RE: **Blythe Solar Power Project, Docket No. 09-AFC-6**
Responses to January 14, 2010 CEC Workshop Queries
Technical Areas:
Soil & Water Resources (supplemental data for DR-S&W-218)

**Soil and Water Resources
(Supplemental Data for DR-S&W-218)**

Blythe Solar Power Project
Docket No. 09-AFC-6

Soil and Water Data Responses to January 14, 2010 CEC Workshop Queries

DRAWING NUMBER
2008-045-CP-008

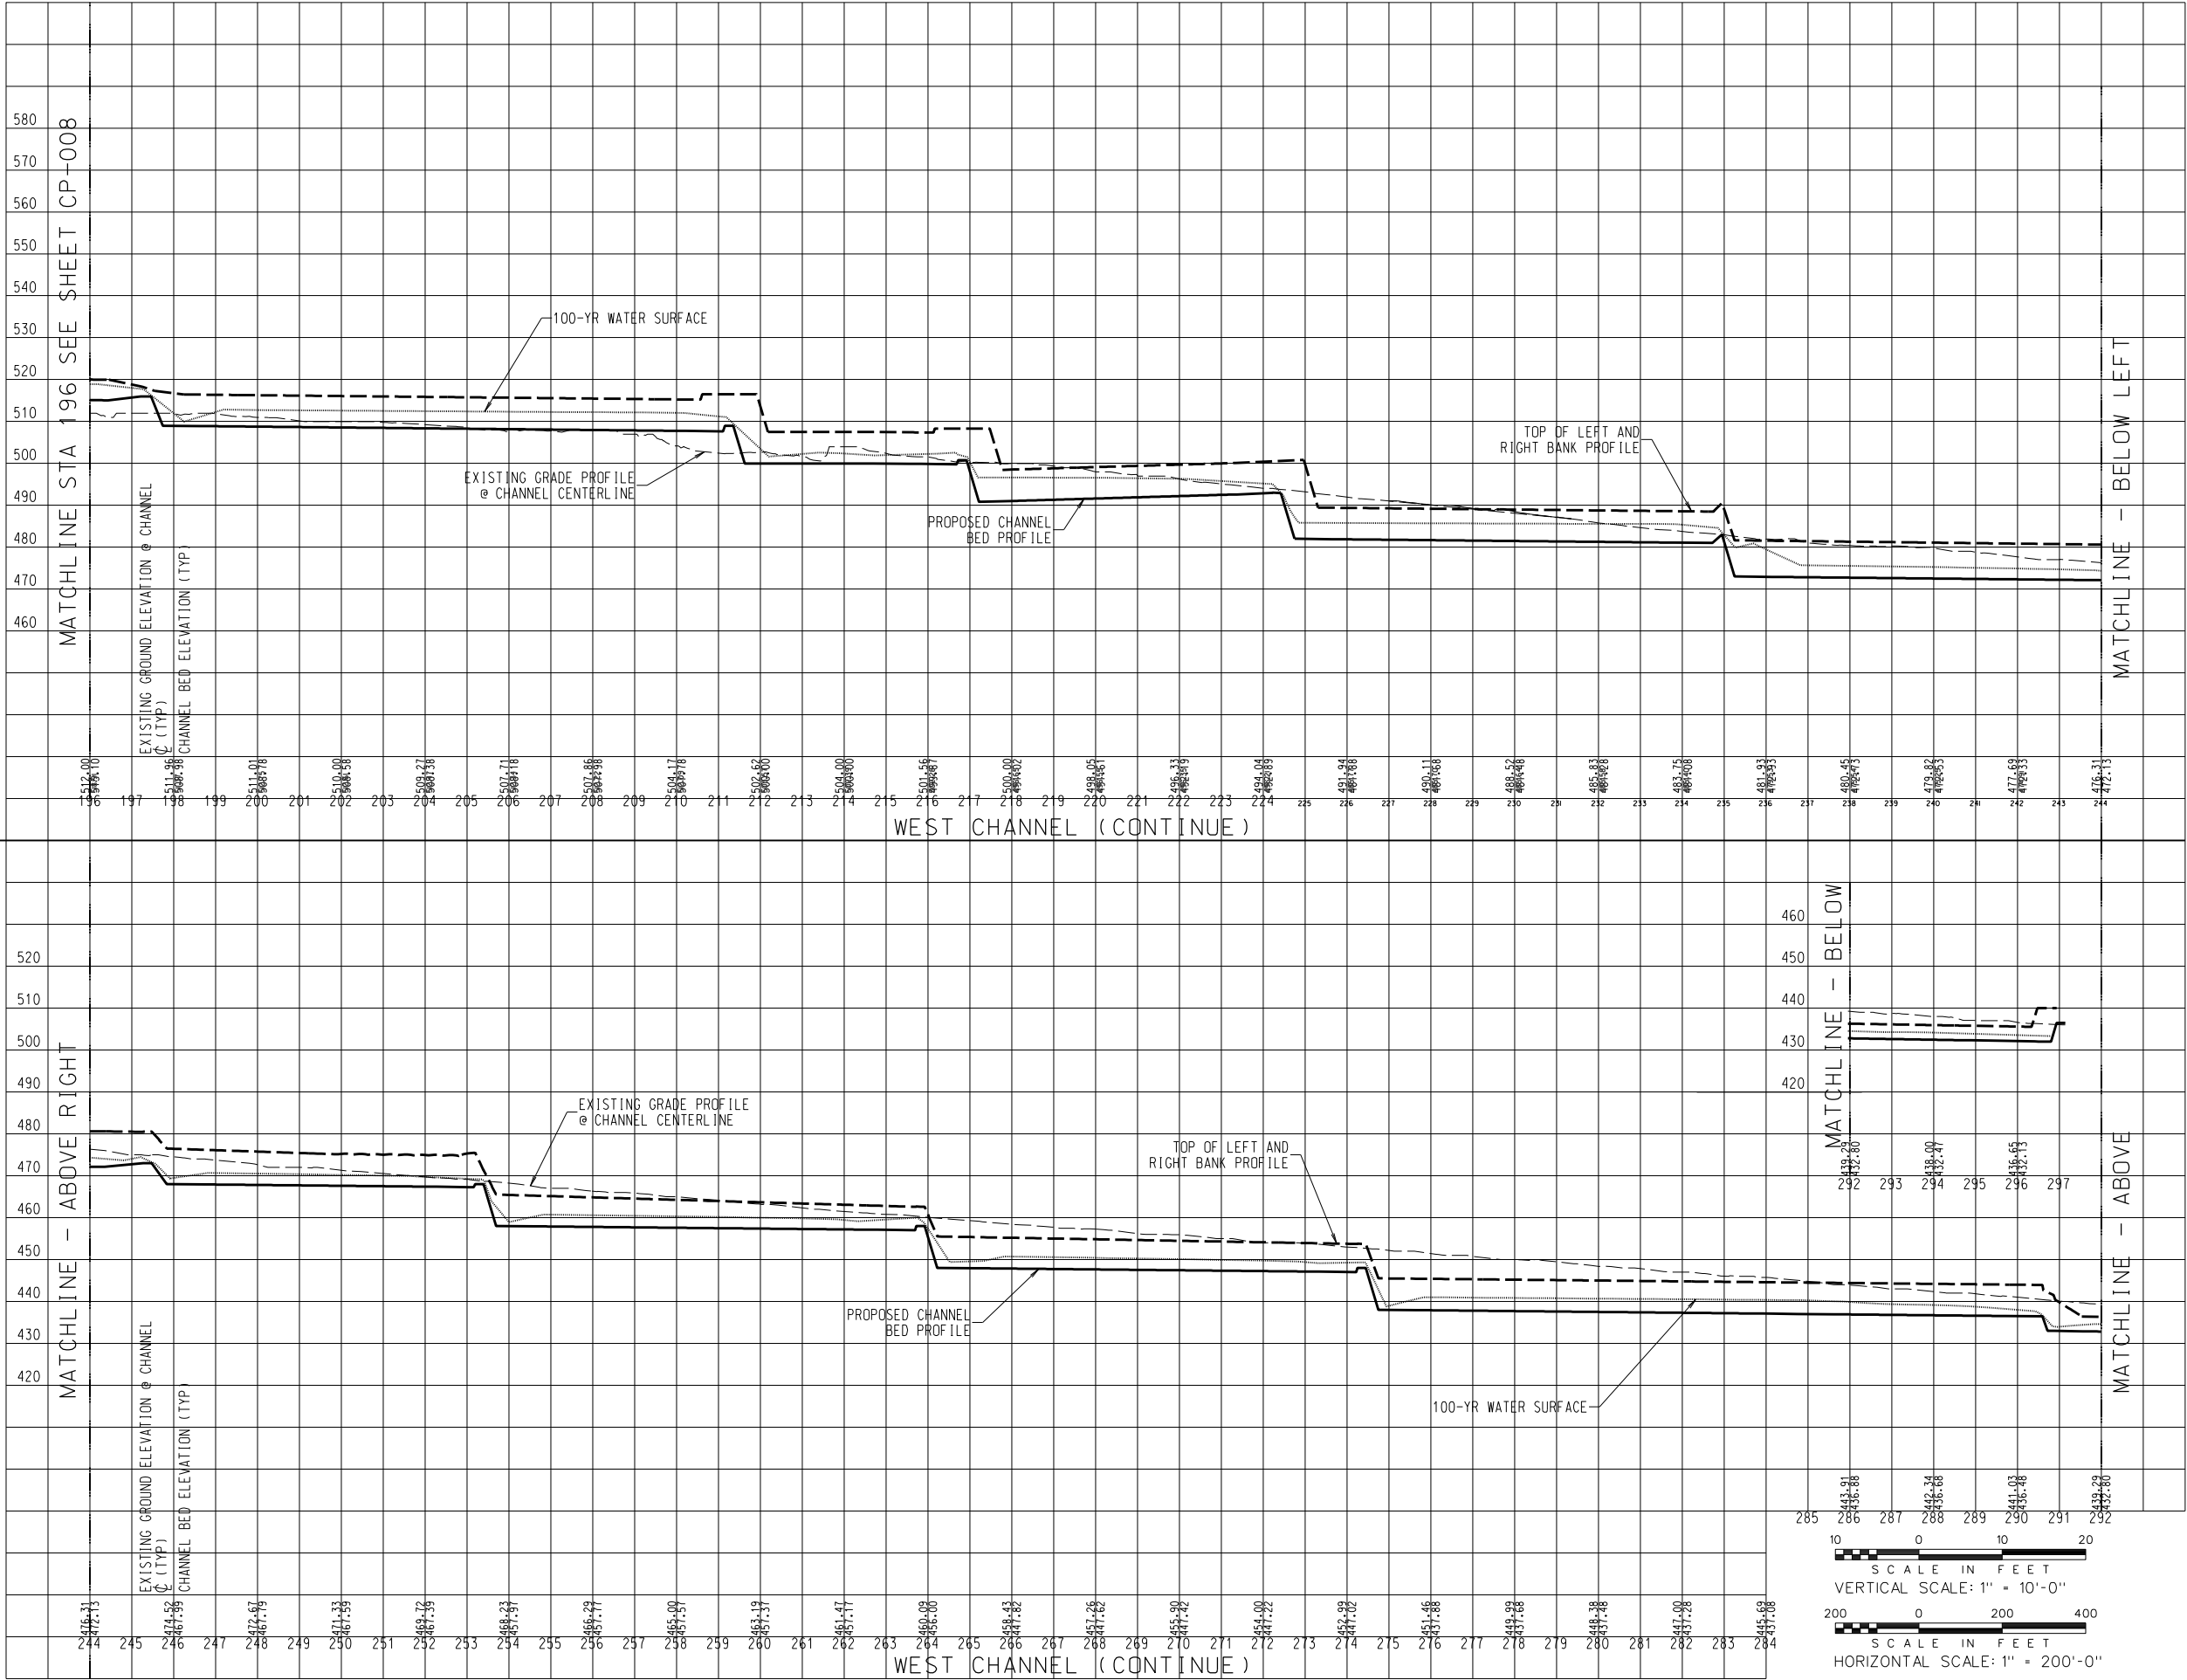
Add 100-yr. water surface elevations on profiles for main channels (both collectors and conveyance).

The 100-year water surface profile has been added to the plans and is provided on Sheets CP-001 to CP-009 as part of this response.
